ADDENDUM NO. 03

Date: June 4, 2024

Project: Conway Corporation
Roger Q Mills Jr.
Water Treatment Plant 8 MGD Expansion & Improvements

The Contract Documents dated May 3, 2024, and Addendum No. 02 issued May 28, 2024, are hereby amended as follows:

SIDEWALK DETAIL A

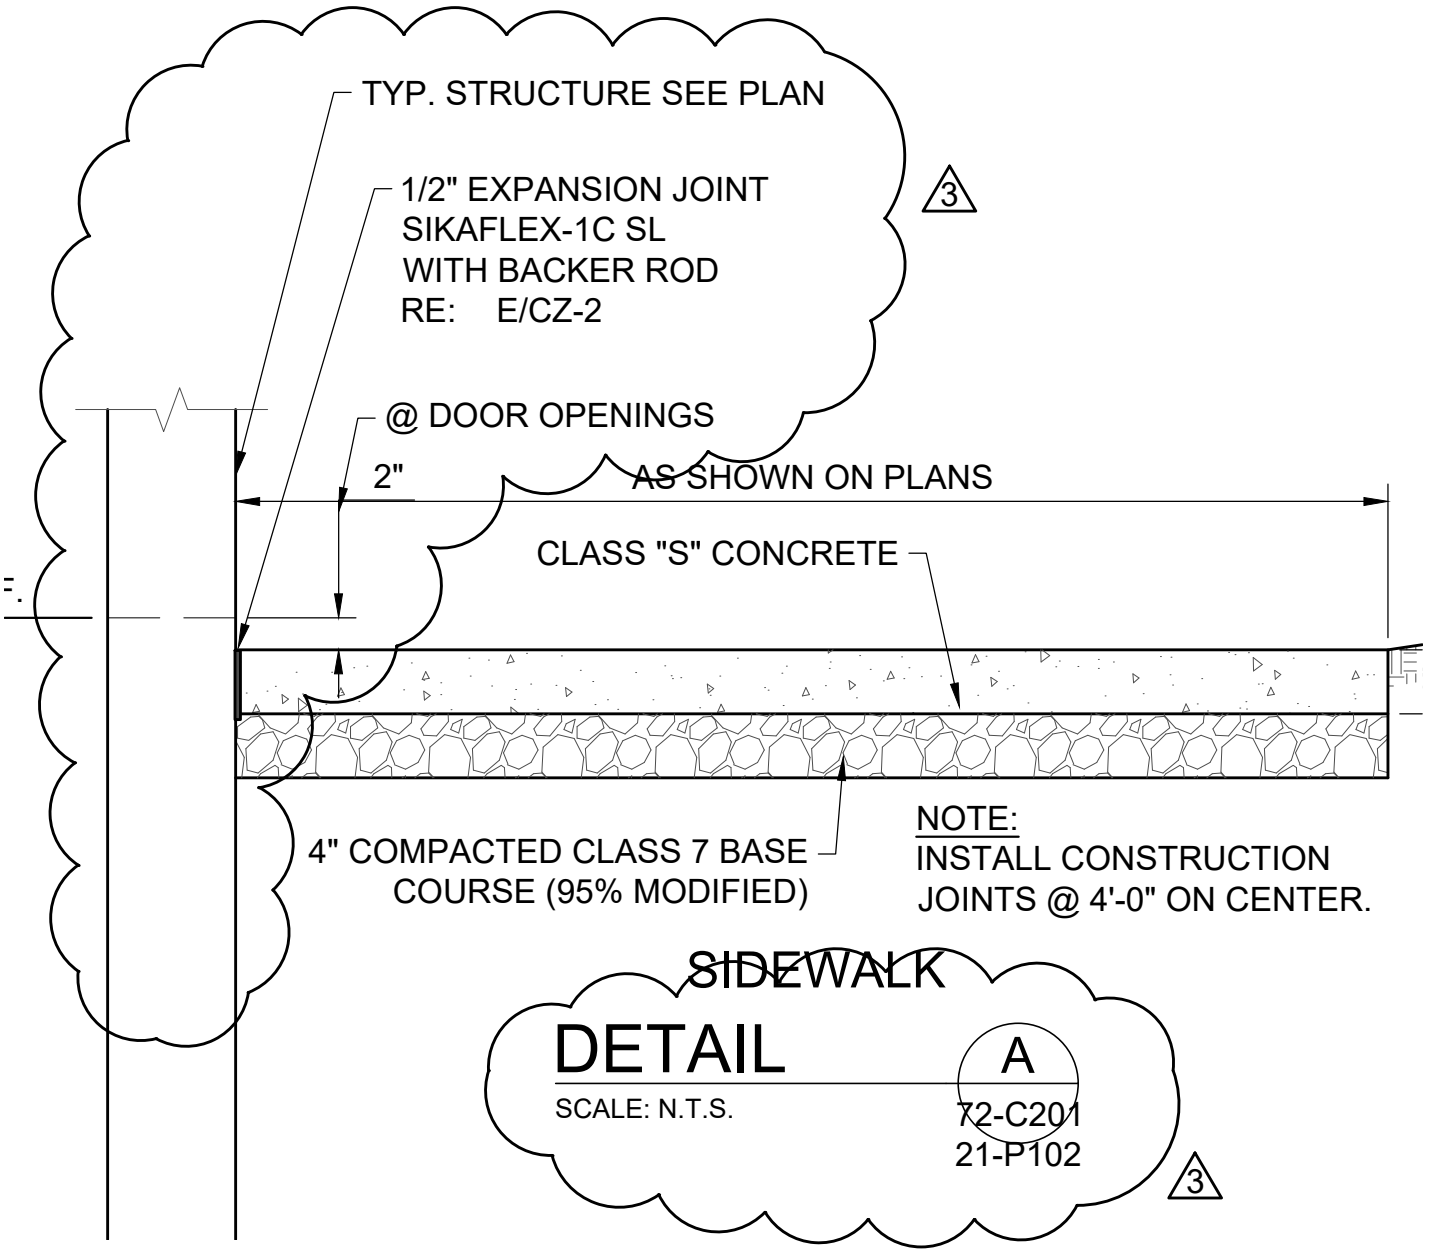
7. Drawing 00-CZ101 (Sheet 27)
   a. Modify the Side Walk Detail shown on Civil Detail II – Addendum 03, attached hereto.

LIME FEED AND ENCASEMENT LINE TRENCHING

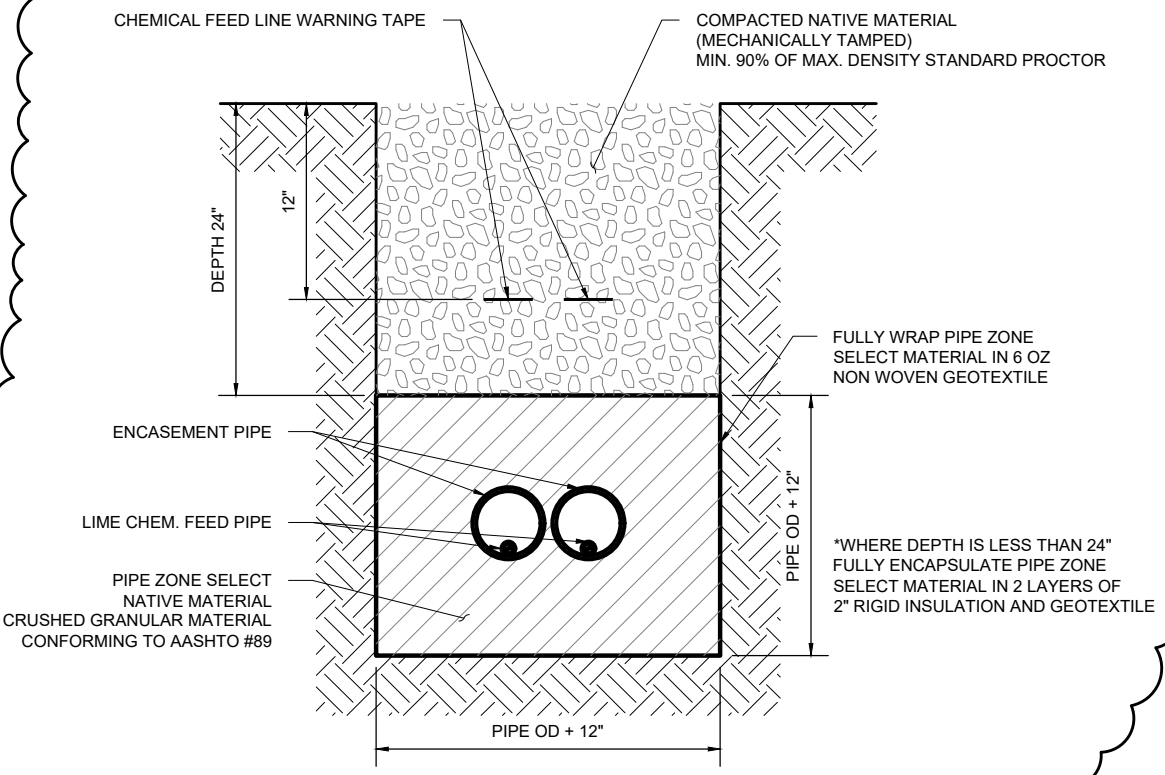
9. Drawing 00-CZ105A (New Sheet)
   a. Add the following detail Lime Feed and Encasement Line Trenching as shown on Civil Details VII – Addendum No. 03, attached hereto.
   b. Add the following detail PAC Feed and Encasement Line Trenching as shown on Civil Details VII – Addendum No. 03, attached hereto.
   c. Add the following detail Concrete Encasement of Pipe Plan and Section as shown on Civil Details VII – Addendum No. 03, attached hereto.

DESIGNED: CAJ	CRIST JOB NO. 2135	DATE 6/04/24	ADD. NO. 3
DRAFTED: MAB	GARVER JOB NO. 19W01300		
CHECKED: CAJ	SCALE: NOT TO SCALE		REF SHEET NEW 10-S400

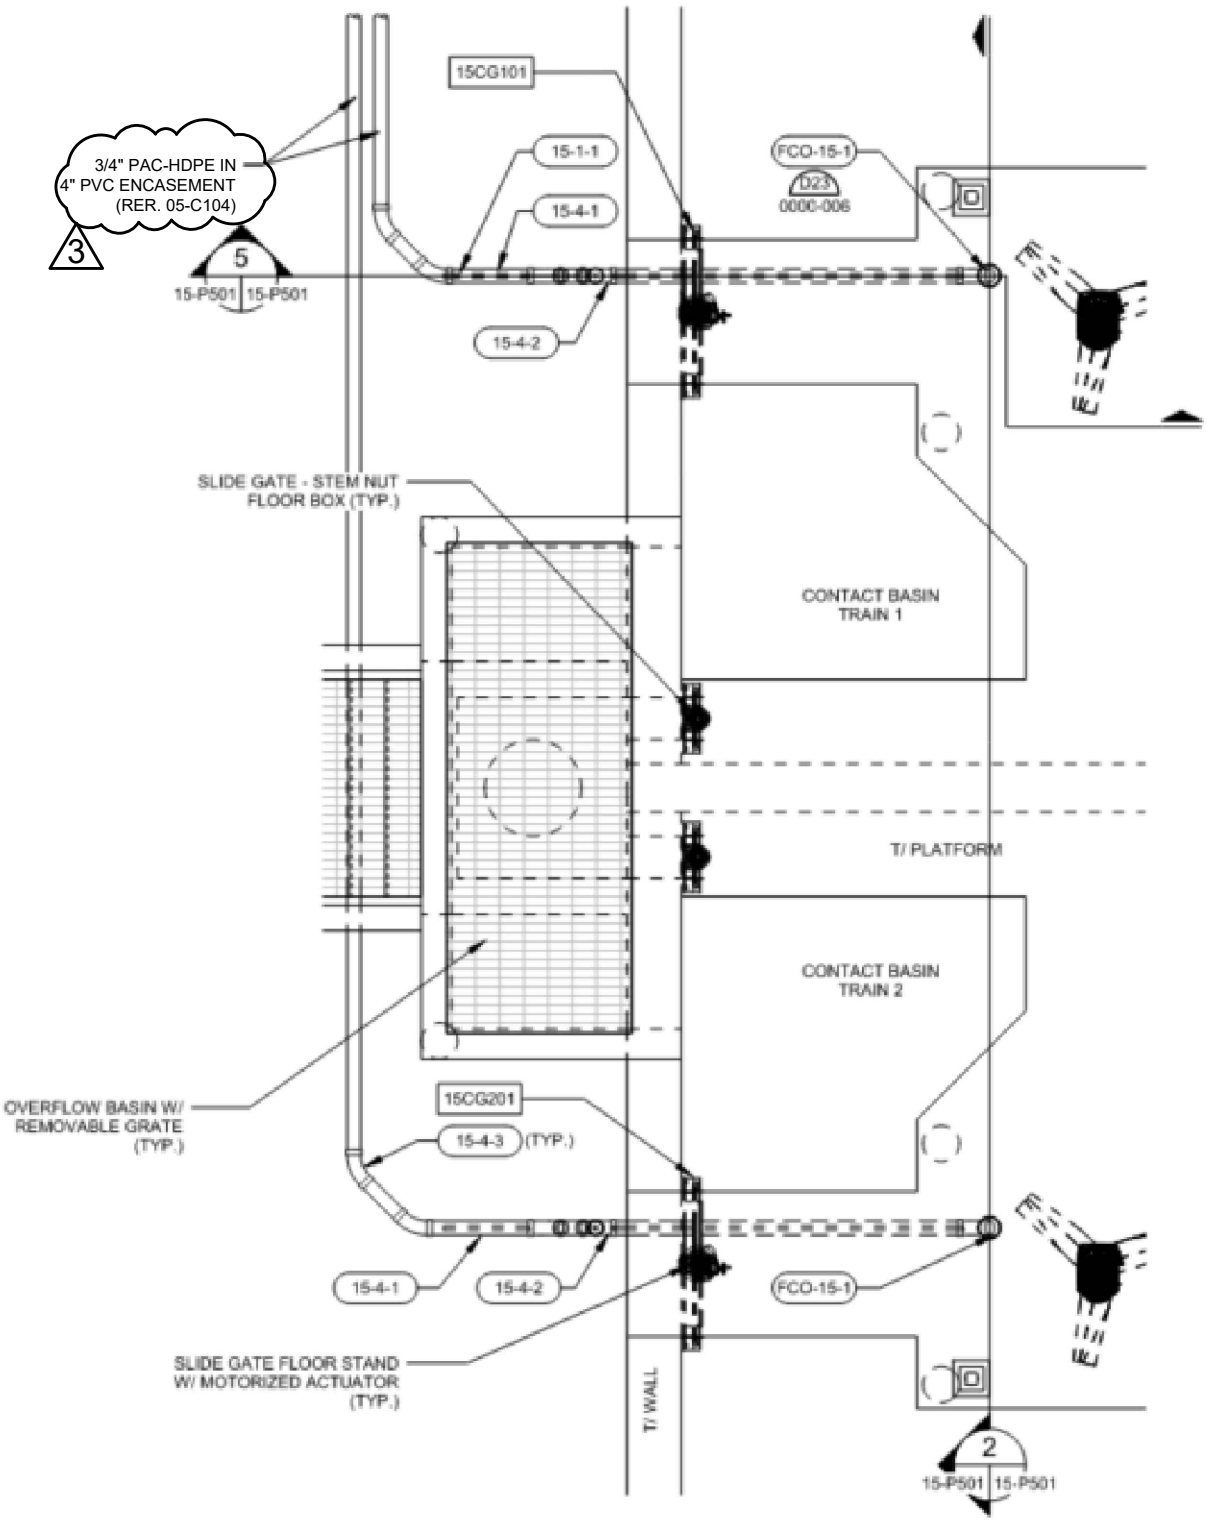
10. Drawing 10-S400 (New Sheet)
    a. Add Foundation and Section Details as shown on the Drain Pump Station Structural Detail, attached hereto.

DESIGNED: CAJ	CRIST JOB NO. 2135	DATE	ADD. NO.
DRAFTED: MAB	GARVER JOB NO. 19W01300	6/04/24	3
CHECKED: CAJ	SCALE: NOT TO SCALE		REF SHEET 21-C300

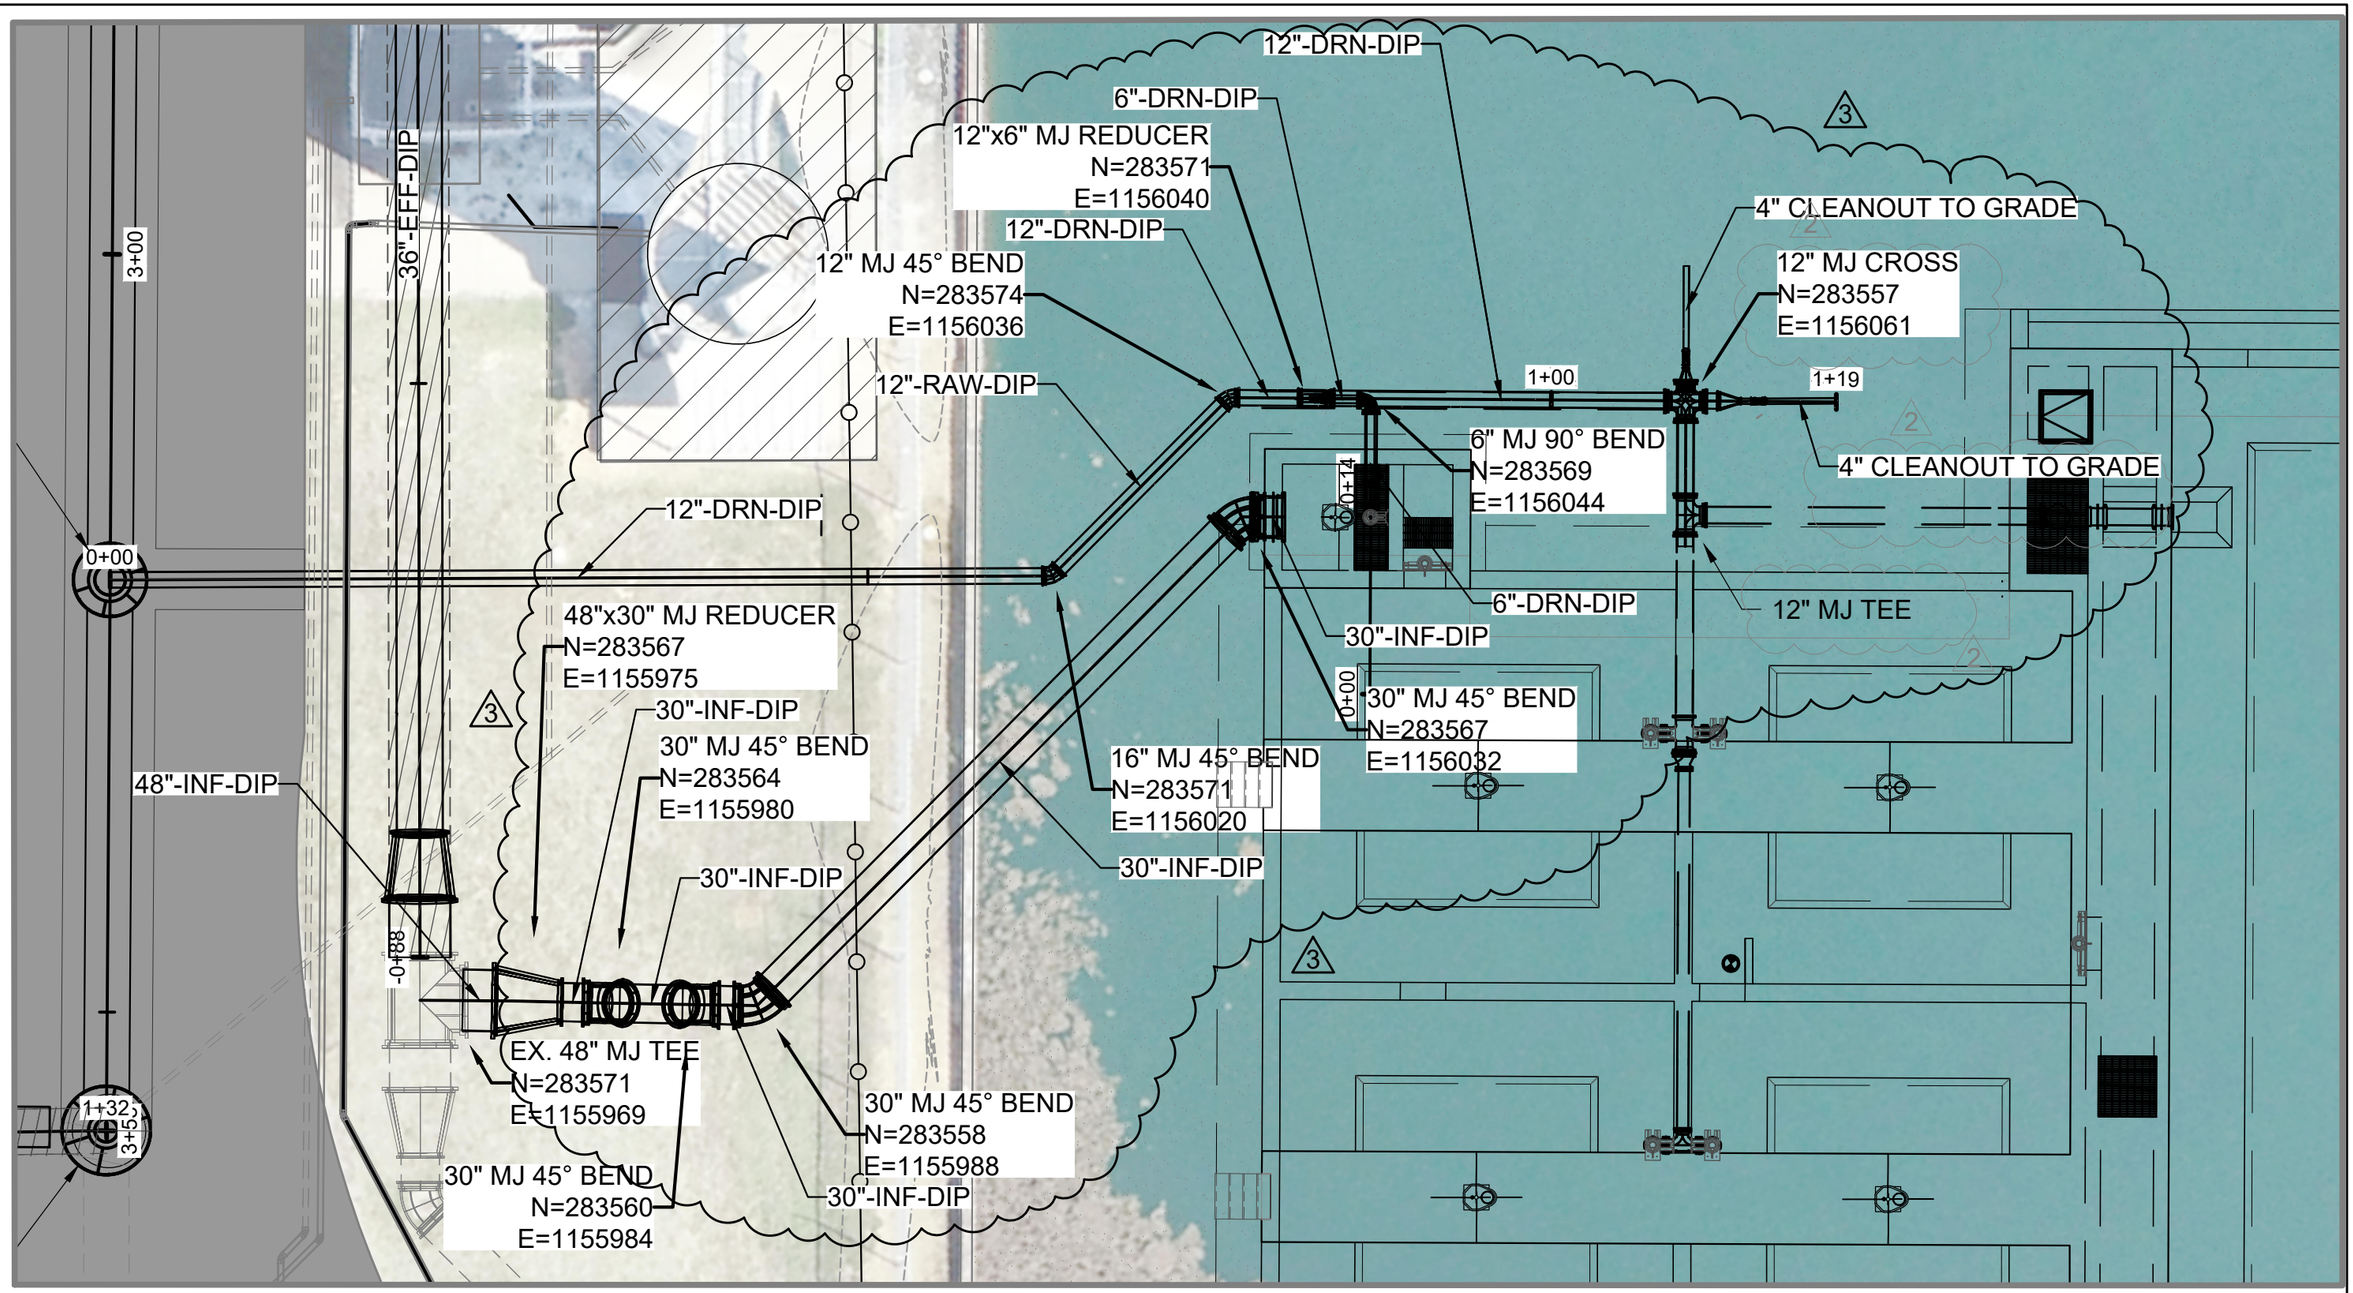
14. Drawing No. 21-C300 (Sheet 112)
    a. Modify the Flocc Influent and Drain as sown on the New Plant Flocculation Piping Plan and Profile – Addendum No. 03, attached hereto.

DESIGNED: CAJ	CRIST JOB NO. 2135	DATE	ADD. NO.
DRAFTED: KEG	GARVER JOB NO. 19W01300	6/04/24	3
CHECKED: CAJ	SCALE: NOT TO SCALE		REF SHEET 21-P502

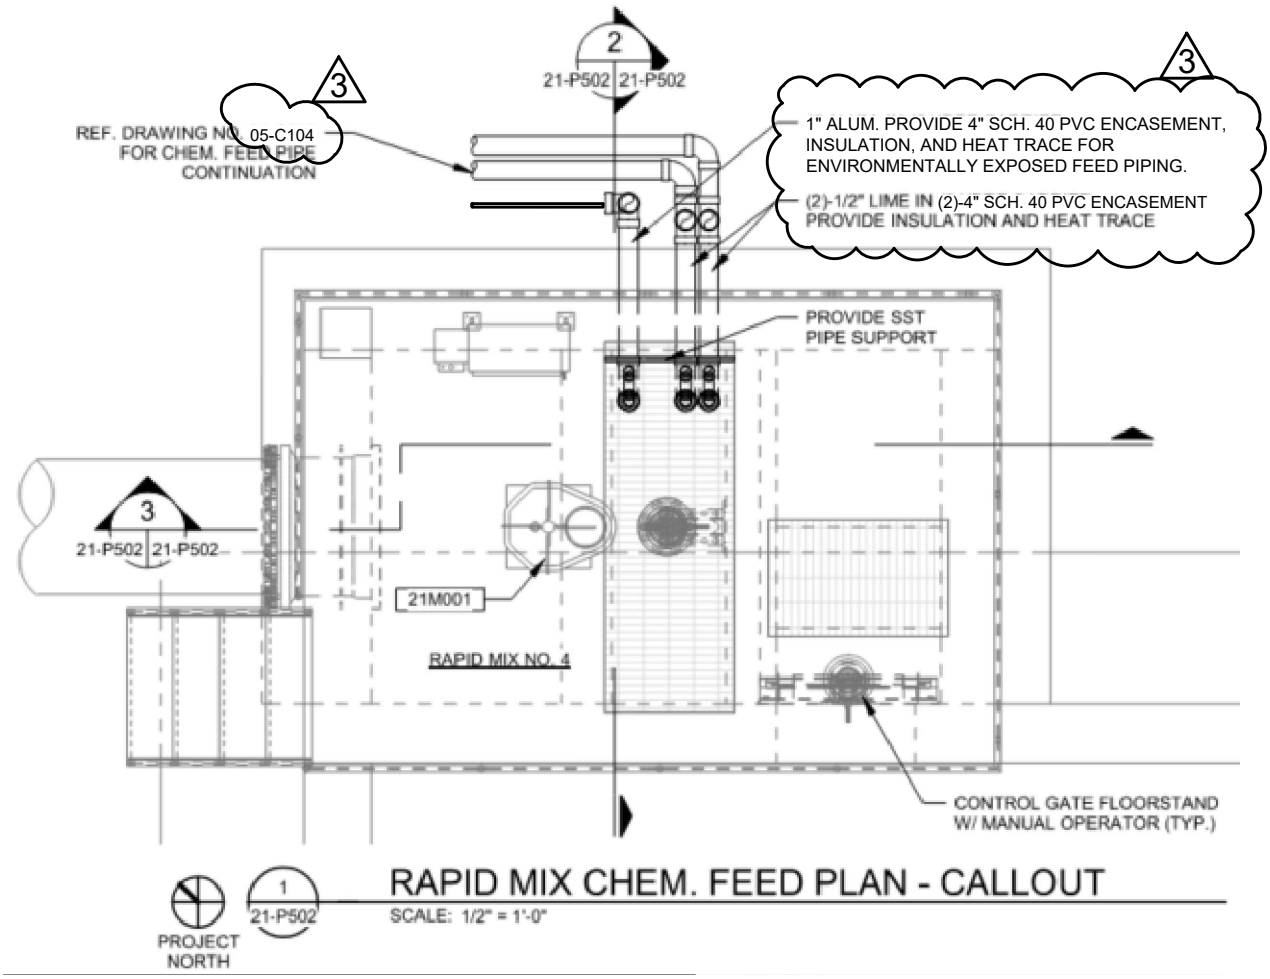
17. Drawing No. 21 P502 (Sheet No. 136)
    a. Modify the Rapid Mix Chem. Feed Plan – Callout as shown on the Chem. Feed Piping Plans and Details – Addendum No. 03, attached hereto.

SECTION A - LOWER STEPS

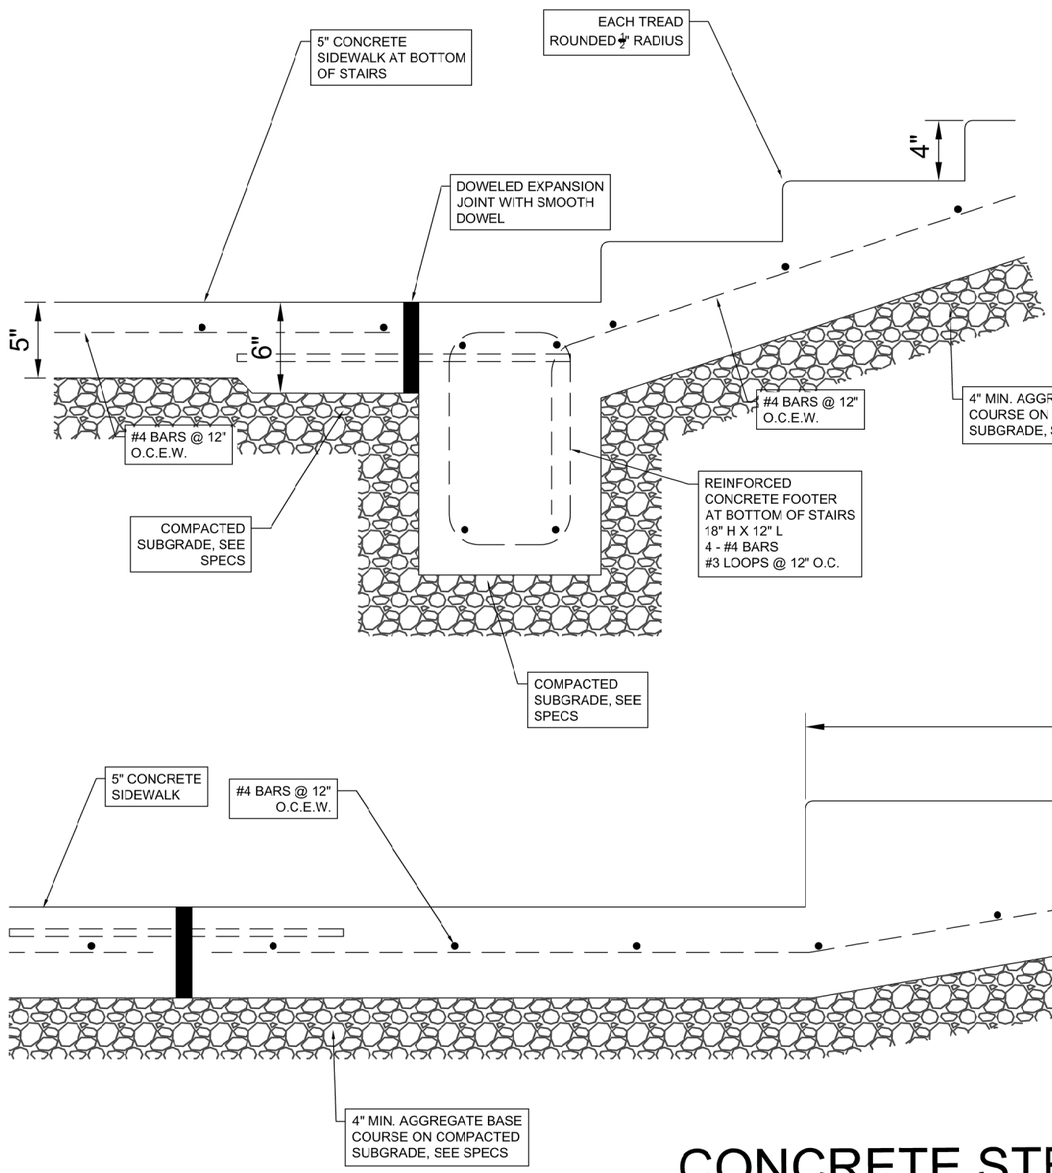
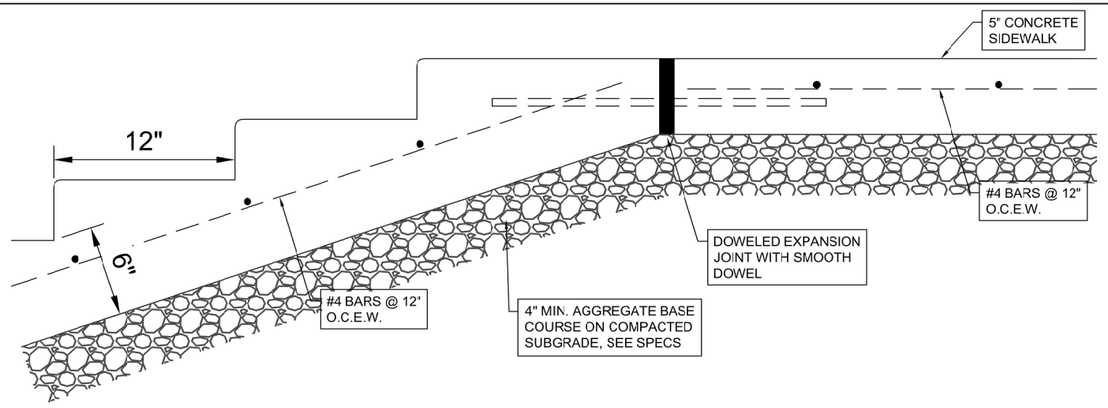
20. Drawing No. 72 C201 (Sheet No. 253)
    a. Modify PAC Contractor and Lime Building Plan as shown on Lime& PAC Feed Site Grading Plan and Section – Addendum No. 03, attached hereto.
    b. Add Concrete Step Next to Lime & PAC Building as shown on Concrete Step Details – Addendum No 03
